Re: Initial Site Review Work Plan Draft
American Zinc Products, LLC
Mooresboro, North Carolina
EPA ID Number NCR 000 159 038

USEPA Comments on

Initial Site Review Work Plan
Draft
Dated: December 3, 2019

American Zinc Products, LLC
Mooresboro, NC
NCR 000 159 038

FIGURE 1
SITE PLAN
AMERICAN ZINC PRODUCTS
AZP MOORESBORO FACILITY

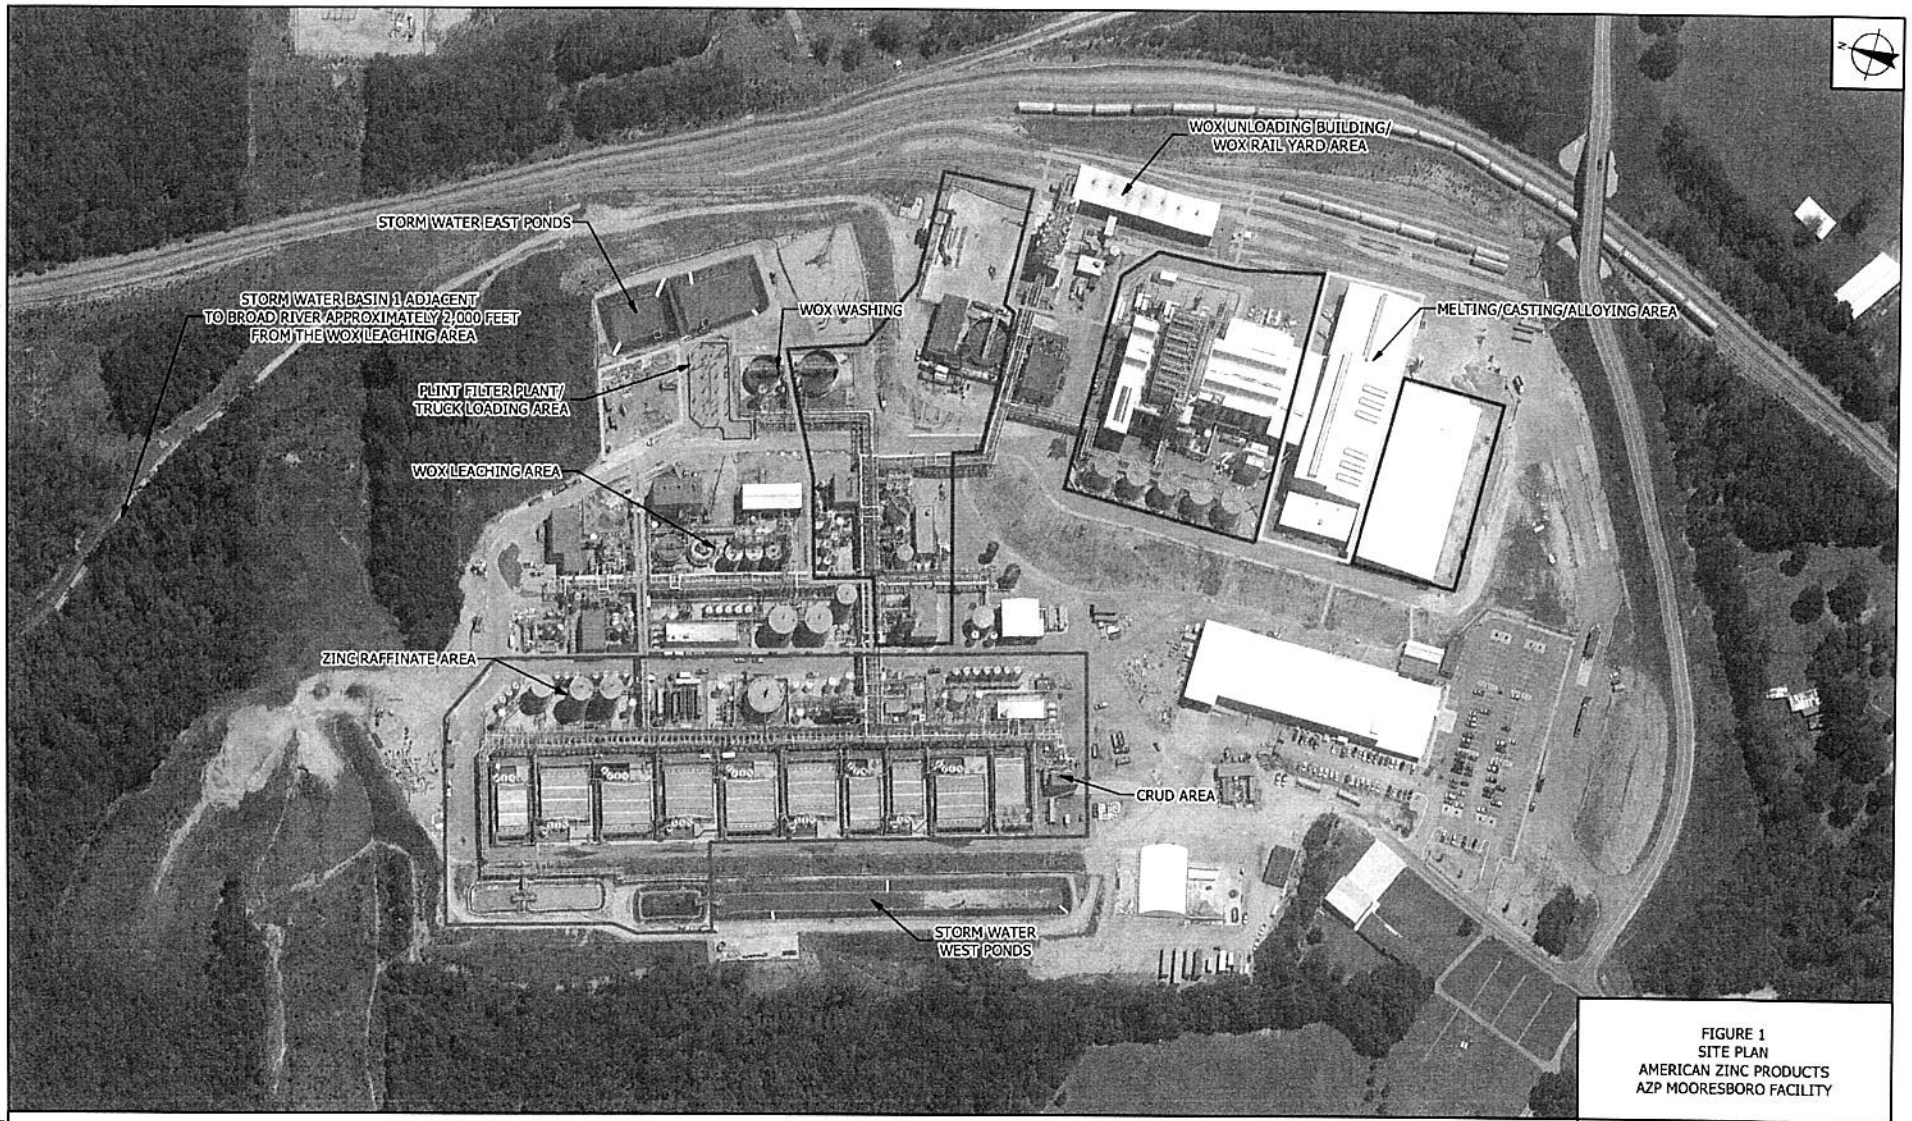
1. Section 5.0
The areas described in Section 5.0 do not match with the names of some of the areas depicted on Figure 1 – Site Plan. For example, are West Ponds (Section 5.0) the same as Stormwater West Ponds (Figure 1)?

2. Section 5.0
There are no descriptions of Solvent Extraction (Area 200) and Bleed Treatment (Area 300). These two areas are listed in Section 2.0 and shown on Figure 1 but are not described in Section 5.

3. Figure 1 – Site Plan
Some areas in the Legend do not correspond to areas depicted on the Site Plan (aerial photograph). For example, in the Legend, WOX Washing is shown bounded by a turquoise color box, but on the Site Plan it is shown bounded by an orange box.

4. Figure 1 – Site Plan
Due south of the area labeled Storm Water West Ponds is a white-roofed building. On the south side of this building there appears to be a retaining wall and gray material piled against it. What is this area and what is the gray material?

1. Section 5.0
The areas described in Section 5.0 do not match with the names of some of the areas depicted on Figure 1 – Site Plan. For example, are West Ponds (Section 5.0) the same as Stormwater West Ponds (Figure 1)?

2. Section 5.0
There are no descriptions of Solvent Extraction (Area 200) and Bleed Treatment (Area 300). These two areas are listed in Section 2.0 and shown on Figure 1 but are not described in Section 5.

3. Figure 1 – Site Plan
Some areas in the Legend do not correspond to areas depicted on the Site Plan (aerial photograph). For example, in the Legend, WOX Washing is shown bounded by a turquoise color box, but on the Site Plan it is shown bounded by an orange box.

4. Figure 1 – Site Plan
Due south of the area labeled Storm Water West Ponds is a white-roofed building. On the south side of this building there appears to be a retaining wall and gray material piled against it. What is this area and what is the gray material?
